STATE OF NORTH CAROLINA  
DEPARTMENT OF TRANSPORTATION

July 6, 2022

Subject: **Revised Modification Request for Section 404 Individual Permit, Section 401 Water Quality Certification and Neuse Riparian Buffer Authorization** for Interstate 40 Widening and Improvements from I-440/US 64 (Exit 301) to just north of SR 1525 (Cornwallis Road), including improvements to NC 42 and SR 1010 (Cleveland Road) in Wake and Johnston Counties, Federal Aid Project No. IMNHF-040-4(139)301; TIP Numbers I-5111 and I-4739, Division 5. Debit \$570 from WBS Element 42346.3.1.

PERMIT DRAWING  
SHEET 31 OF 125

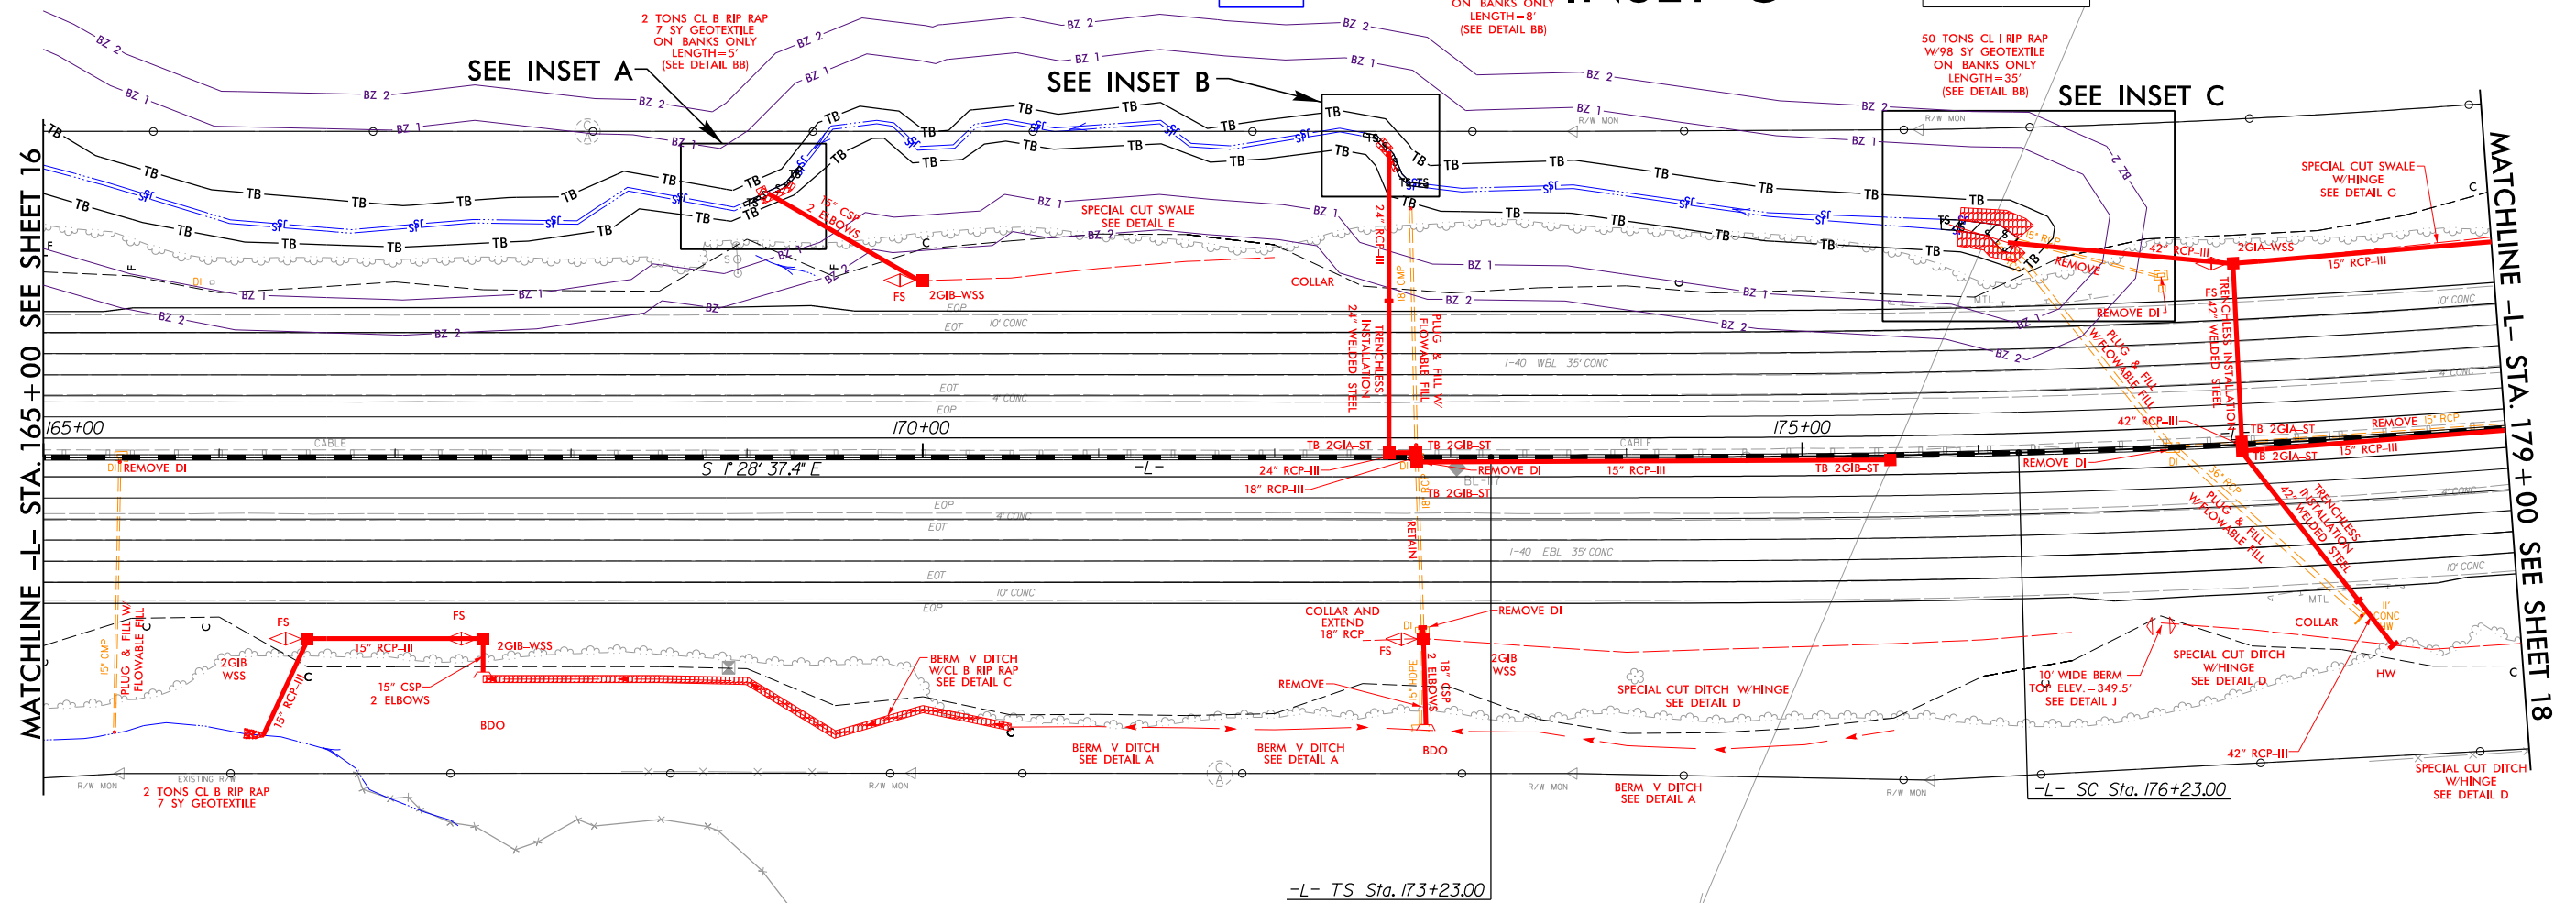
Site 14A: The pipe was installed at this site on June 22<sup>nd</sup>, and field conditions dictated that additional bank stabilization is needed. NCDOT asked that rip rap be placed upstream of the pipe outlet, in addition to the bank stabilization that was originally permitted. This change will result in the following changes in impacts:

- 15 linear feet increase in permanent stream impacts (bank stabilization)
- 400 square feet increase in mitigable buffer zone 1 impacts
- 186 square feet increase in mitigable buffer zone 2 impacts

Site 14B: Similar to site 14A, the pipe installation at this site requires additional bank stabilization upstream of the new pipe. This is in addition to the originally permitted bank stabilization below the new pipe. This change will result in the following changes in impacts:

- 12 linear feet increase in permanent stream impacts (bank stabilization)
- 12 linear feet decrease in temporary stream impacts (bank stabilization)
- No changes in buffer impacts.

PERMIT DRAWING  
SHEET 111 OF 125

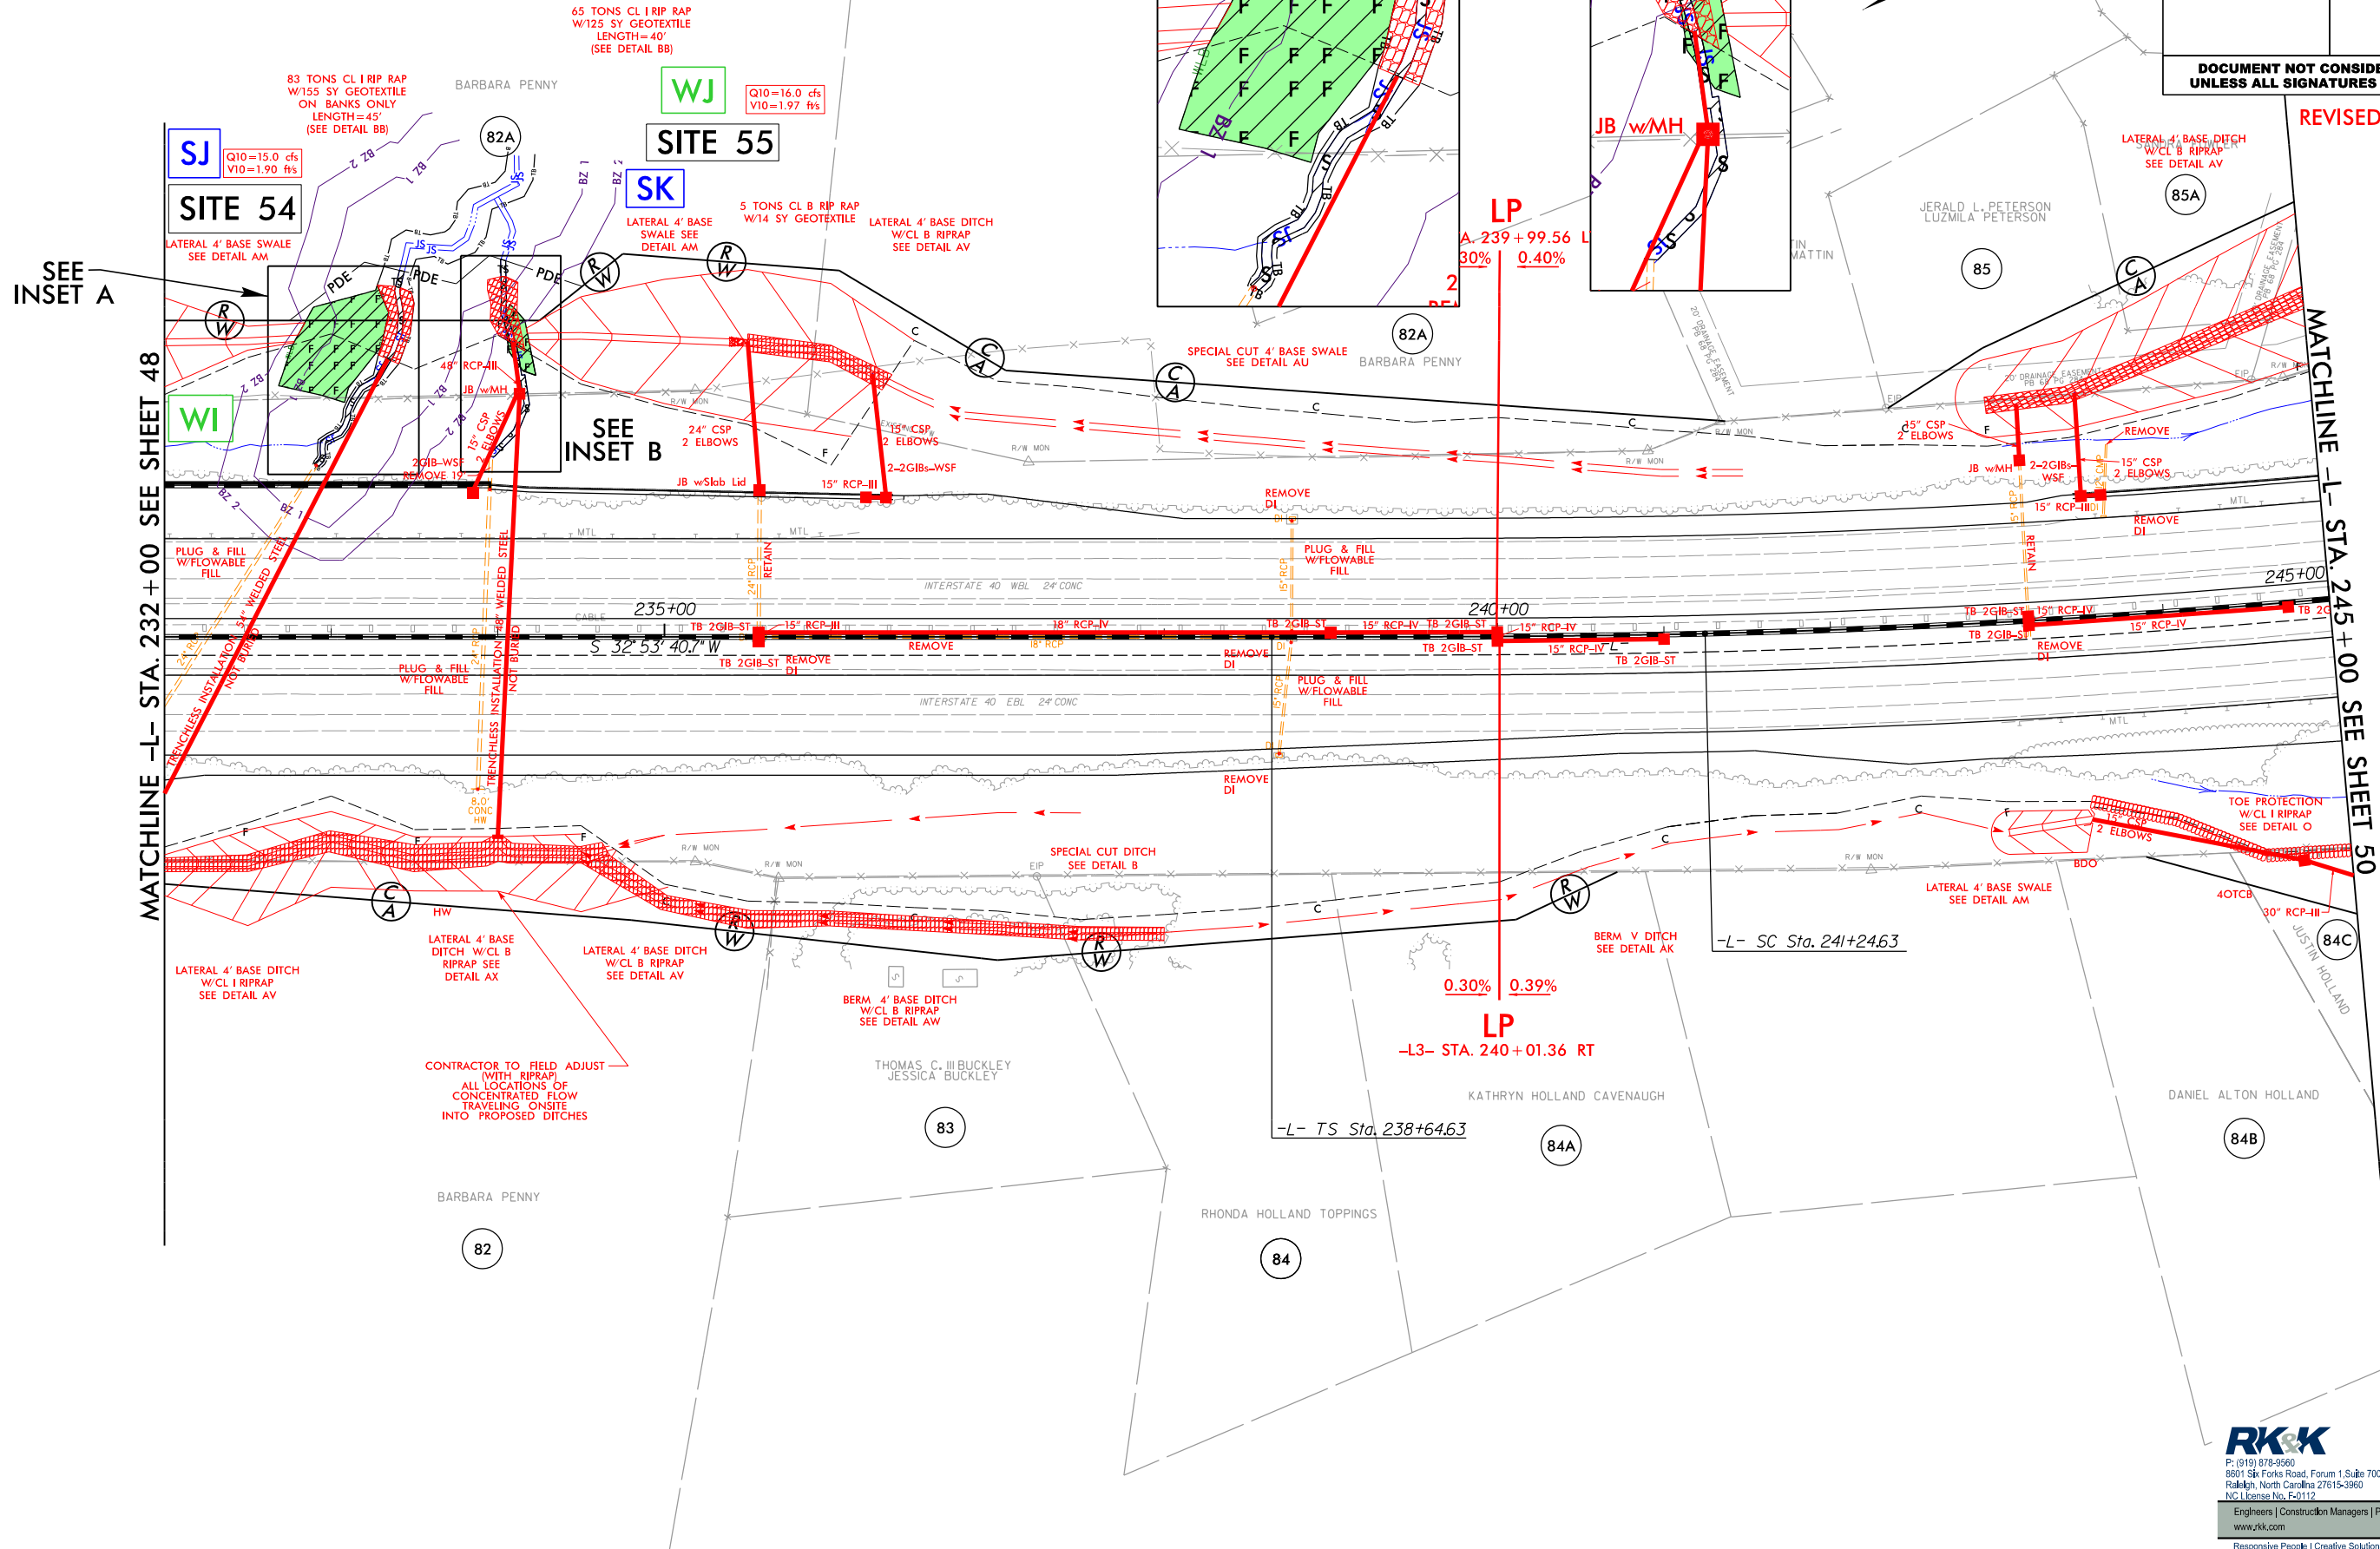
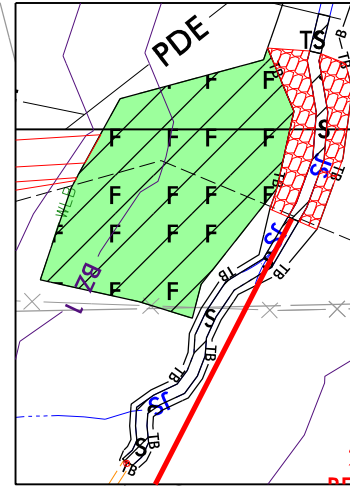
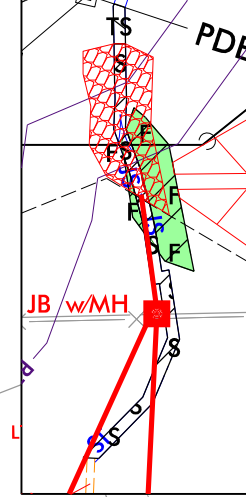
Site 55: Due to repeating erosion events and the general instability of the channel below the outlet of Site 55, the Design Build Team proposes rip rap be added to the flow line to match the length of the previously permitted bank stabilization. This will result in the following changes:

- 40 linear feet decrease in bank stabilization impacts
- 40 linear feet increase in permanent stream impacts
- No changes in buffer impacts
